Miller on Camellia Ct

Hi Lorraine,

In this repository you will find my notes with regards to getting the Miller design on our property as per our requirements. Even a knock-down rebuild of my current home which was built in the 70's would require report and consent to be approved via council due to nature of the odd shaped block.

Miller stting Figure 2:

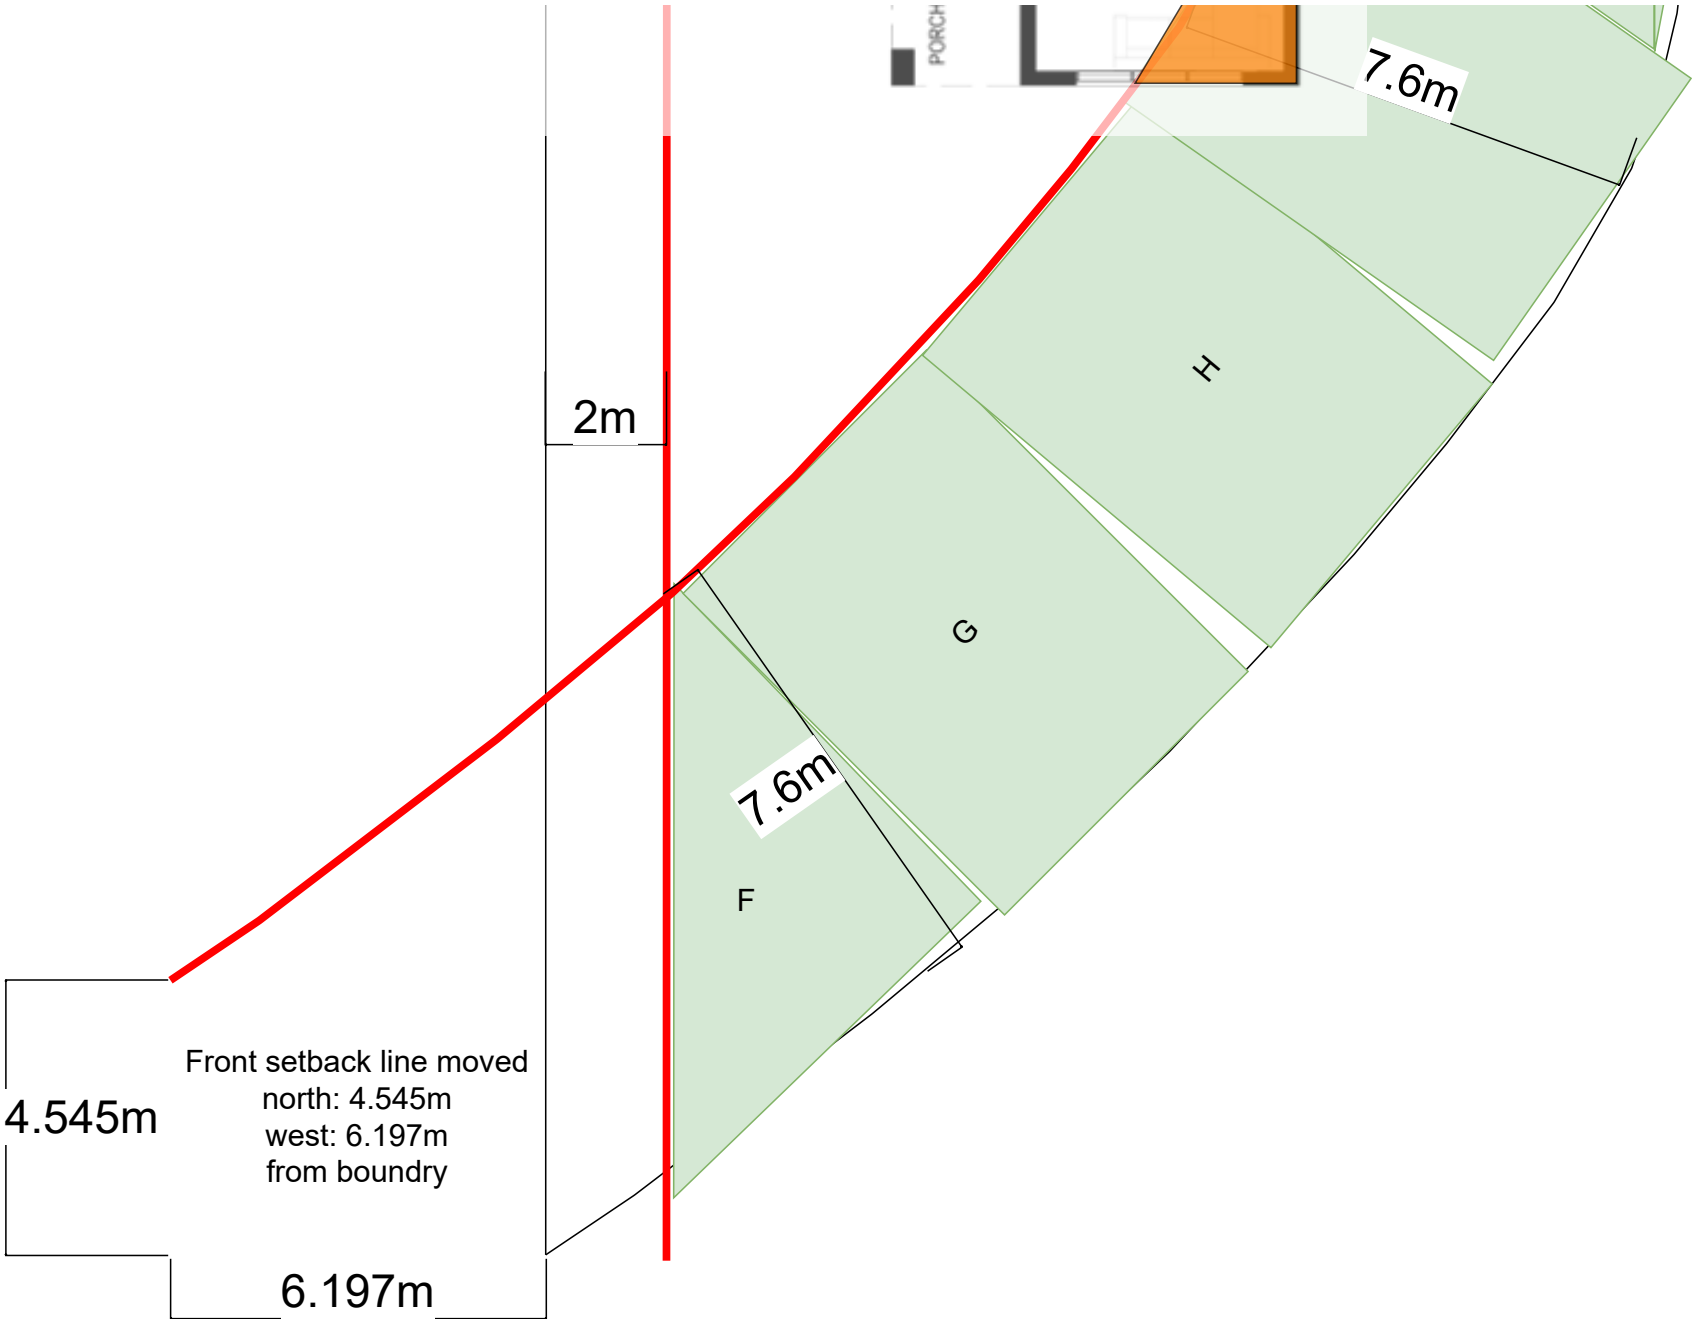
To be more consistent in line with other houses in the court a slight preference has been given to reducing the front setback violation over the rear setback violation.

This sitting of the Miller design on this property tries to achieve the most likely approvable positioning with regards to rear & front setbacks.

The regions marked in orange are the violations (ie. the areas of concern that encrouch the setbacks). These violations should however be considered in context of the setback areas.

Setback		Total Surface Area	Violation Area
Front (ie. south)		214m2	8m2
Rear (ie. north)		69m2	9m2

In the context of things, these are the smallest violations that I could achieve which I feel will result in approval by council. Please have your draftsperson verify my sitting position as perhaps they may find a better sitting.

Figure 3: Ground level changes

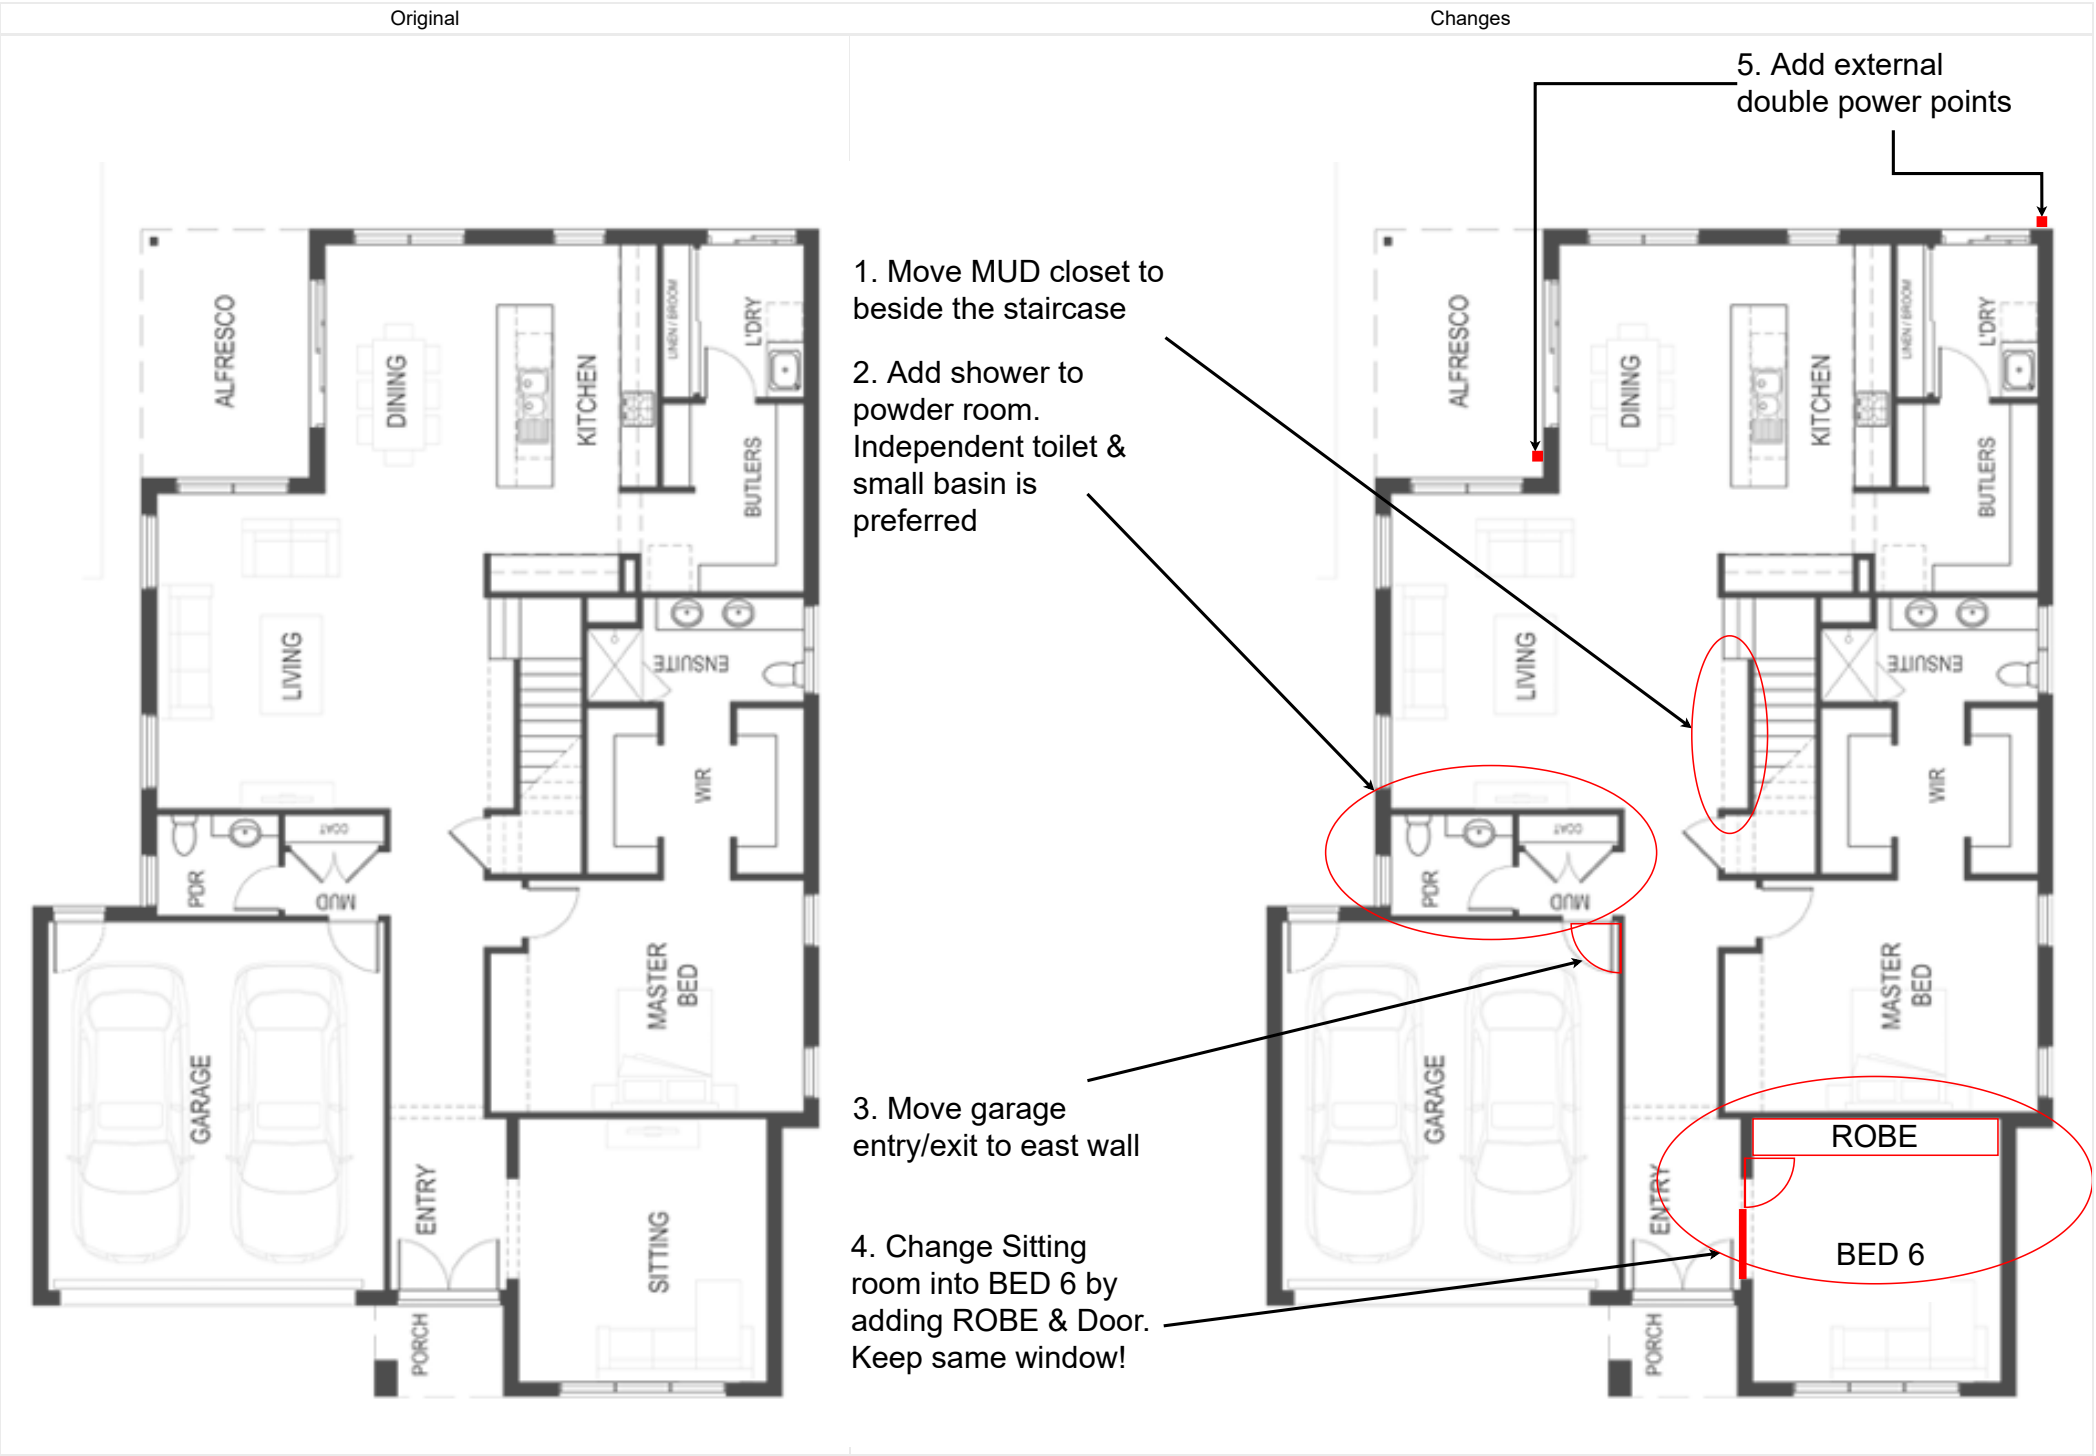
The following are the preferred changes to the ground level:

- Move MUD closet to beside the staircase
- Add shower to powder room. Independent toilet & small basin is preferred
- Move garage entry/exit to east wall
- Change Sitting room into BED 6 by adding ROBE & Door. Keep same window!
- Add external double power points

Note, BED 6 may get transformed back into Sitting room if we ever decide to sell.
